ITEM (A): ROWE STREET (EAST), EASTWOOD
SUBJECT: CHANGE OF PARKING RESTRICTIONS

ELECTORATE: RYDE
 WARD: WEST
 ROAD CLASS: NON-CLASSIFIED
 REFERENCE: T2020-00900

ITEM (B): 12 TRELAWNEY STREET, EASTWOOD
SUBJECT: CHANGE OF PARKING RESTRICTIONS

Figure 1: Rowe Street – Temporary change of 1P to 2P.

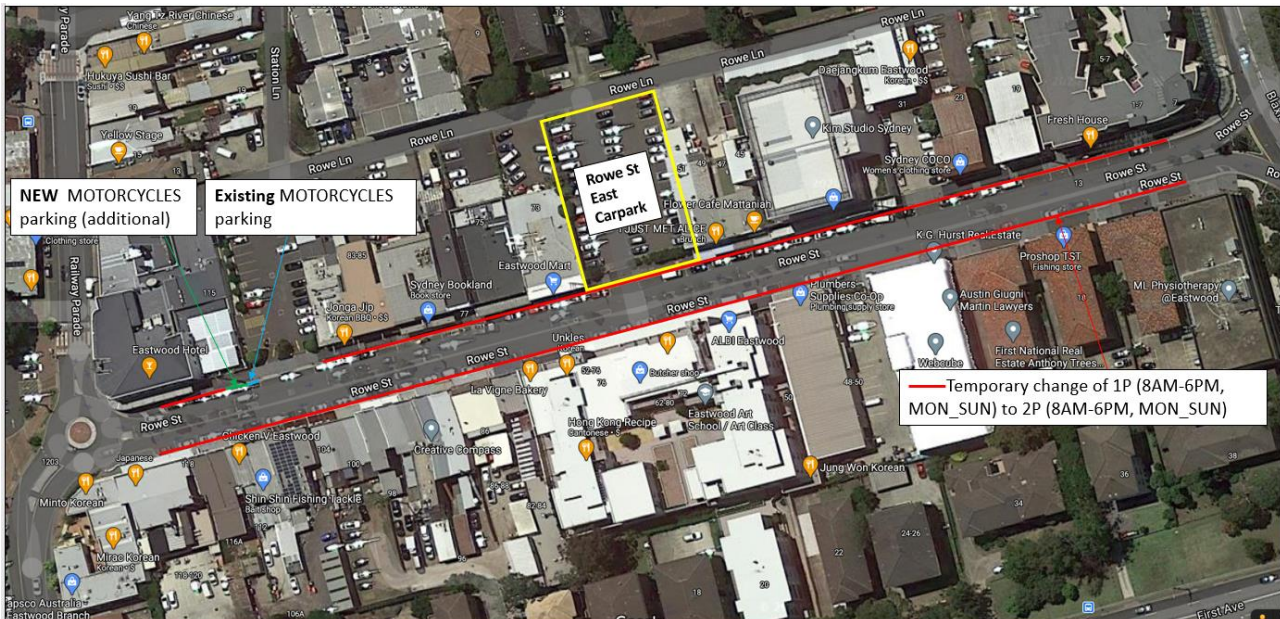
The Korean Chamber of Commerce has requested the 1P (8AM-6PM, MON_SUN) parking along Rowe Street be temporarily changed to 2P (8AM-6PM, MON_SUN) to cater for the loss of parking spaces during the construction of the Rowe Street East Carpark. The car park is expected to be completed by July 2021. Refer to Figure 1 below.

- a) 1P (8AM-6PM, MON_SUN) parking along Rowe Street be temporarily changed to 2P (8AM-6PM, MON_SUN) until the completion of the Rowe Street East carpark in July 2021.
- b) Convert a single 1P car park space to “NO STOPPING, MOTORCYCLES EXCEPTED” in front of the Eastwood Hotel.
